**DEPARTMENT OF TRANSPORTATION**

Contract #: 04-0120F4Cty: SF/ALA Rte: 80 PM: 13.2/13.9File #: 69.28**WELDING INSPECTION REPORT****Resident Engineer:** Siegenthaler, Peter**Address:** 333 Burma Road**City:** Oakland, CA 94607**Report No:** WIR-018234**Date Inspected:** 17-Nov-2010**Project Name:** SAS Superstructure**OSM Arrival Time:** 700**Prime Contractor:** American Bridge/Fluor Enterprises, a JV**OSM Departure Time:** 1900**Contractor:** Zhenhua Port Machinery Company, Ltd (ZPMC), Changxing Island **Location:** Shanghai, China**CWI Name:** Xu Tao**CWI Present:** Yes No**Inspected CWI report:** Yes No N/A**Rod Oven in Use:** Yes No N/A**Electrode to specification:** Yes No N/A**Weld Procedures Followed:** Yes No N/A**Qualified Welders:** Yes No N/A**Verified Joint Fit-up:** Yes No N/A**Approved Drawings:** Yes No N/A**Approved WPS:** Yes No N/A**Delayed / Cancelled:** Yes No N/A**Bridge No:** 34-0006**Component:** OBG Components**Summary of Items Observed:**

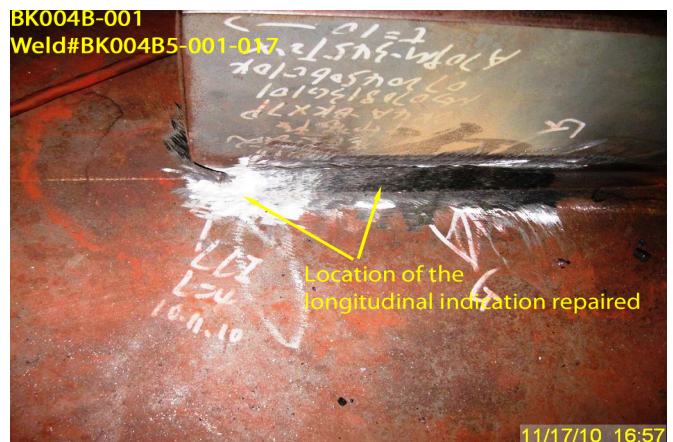
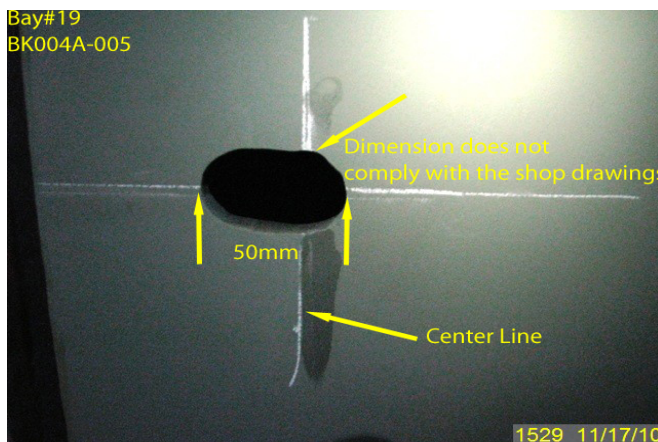
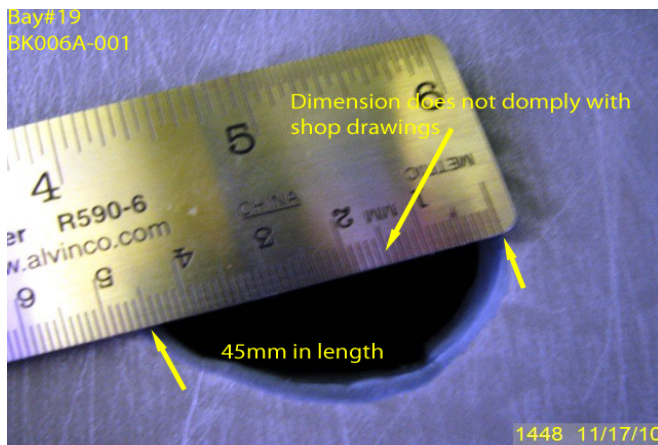
During random visual observation of the bike path, this QA inspector observed following issues.

-The slotted hole on the Bike Path Bearing Plate does not comply with the approved shop drawing.

-According to the shop drawing, the dimension of the slotted hole is 64x34.

-The slotted holes were measured as 45x34.

-The bearing Plate is identified as BKPL7A (BK004A) and BKPL14A (BK006A)

-The bike path component is identified as; BK006A-001, BK004A-012 and BK004A-005.

-The bike paths are located inside bay#19.  
For further information, please find attached pictures

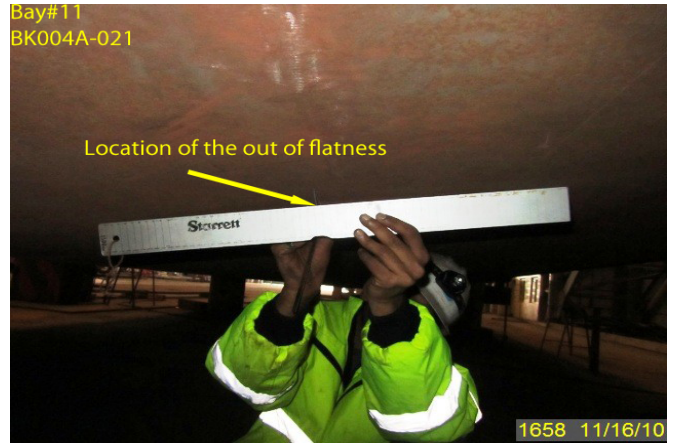
During Quality Assurance (QA) Critical Weld Repair (CWR) verification inspection at Bay#19 of Bike Path welds, this Caltrans QA Inspector observed the following issues:

- QA Inspector was notified via email for verification of B-CWR2228 R0 at 16:25 hours.
- The Bike Path component for verification was identified as BK004B-001.
- The welds are identified as; BK004B3-001-051, total three (3) linear transverse indications  
And BK004B5-001-017, total four (4) linear longitudinal indications.
- The transverse indications measuring approximately 10mm & 15mm in length and the longitudinal indications measuring approximately 15mm & 25mm were found at this location, which required an approved CWR prior to starting repairs.
- ZPMC repaired these indications prior to the QA inspector's CWR verification.
- BK004B-001 is located in Bay 19.

For further information, please see the attached pictures below. Please see incident report on this date.
